Amendments to the Drawings:

REMARKS

Objection to the Drawings

FIG. 8

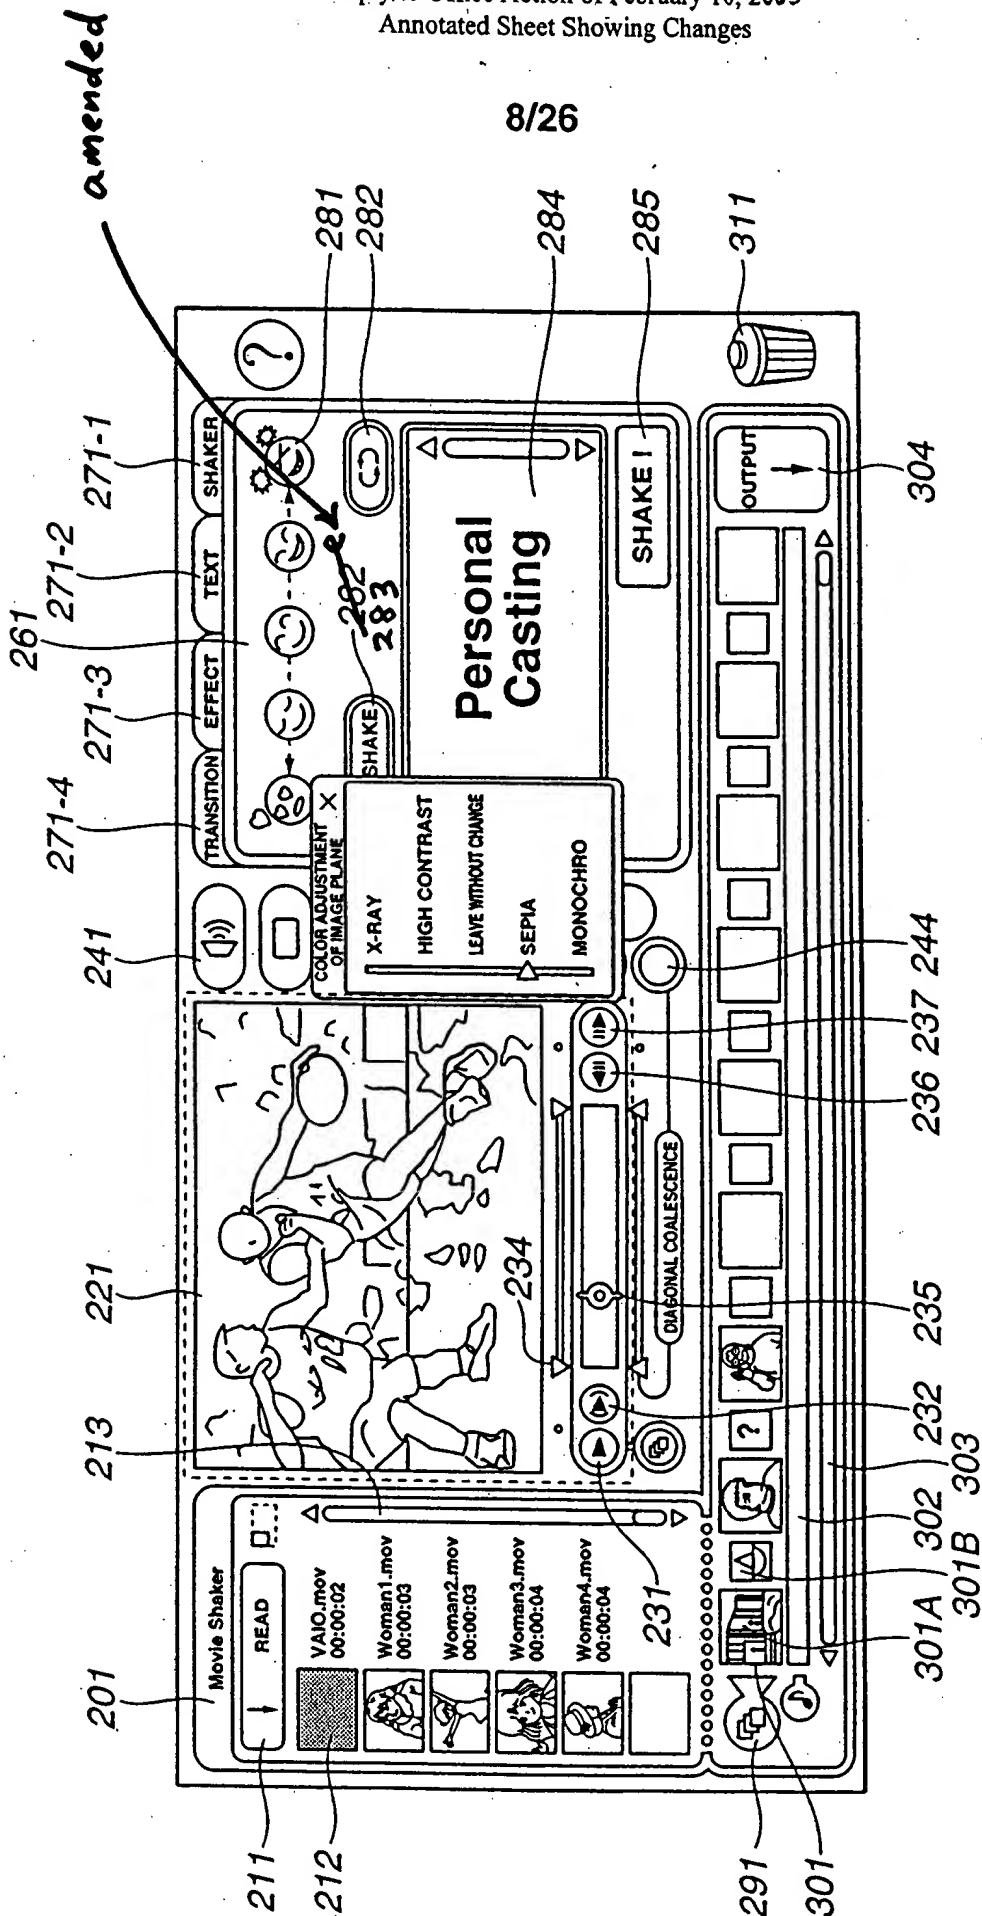
The attached sheets of drawing include changes to Fig. 8. This sheet replaces the original sheet including Figs. 8. In Figure 8, designator '282' designating the "shake" button has been changed from '282' to '283'.

In Section 8 of the Office Action, the drawings stand objected to with respect to reference number "282" in Figure 8. Figure 8 has been amended to obviate this objection.
